Fuel Cells of the V-22 *Osprey* Joint
Advanced Vertical Aircraft
(D-2003-013)

SUBJECT: Report on the Fuel Cells of the V-22 *Osprey* Joint Advanced Vertical
Aircraft (Report No. D-2003-013)

Appendix M. Navy Response to Questions on the System Safety Risk Assessment for V-22 Fuel Cells

Appendix N. Analysis of the Navy Response to Issues With the System Safety Risk Assessment for V-22 Fuel Cells

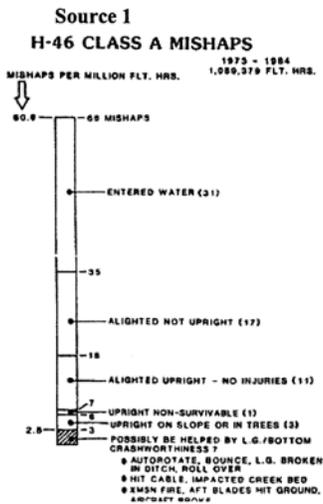
7. What was the source for the data that was used to develop the "probability that a crash occurs over land" factor, what was the population and population size the data was developed from, and what timeframe does the data represent? Please provide a copy of the data used.

The V-22 is a replacement for the H-46. The data below fully supports the 50% over land statement.

H-46 Data: Source 1 data source shows 31/66 = 47% water crashes, Source 2 data 57% water crashes, Source 4 data shows 32/52 or 62% water crashes.

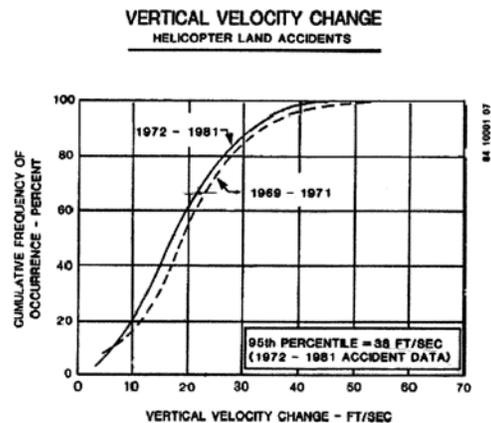
8. Please provide evidence that the factors "probability that a crash is survivable" and "probability that a crash occurs over land" are actually mathematically independent factors.

Source 4 data indicates that:

32 of the 157 water mishaps (or 20% of water mishaps were considered non-survivable).
44 out of 127 land mishaps (or 35% of land mishaps were considered non-survivable).
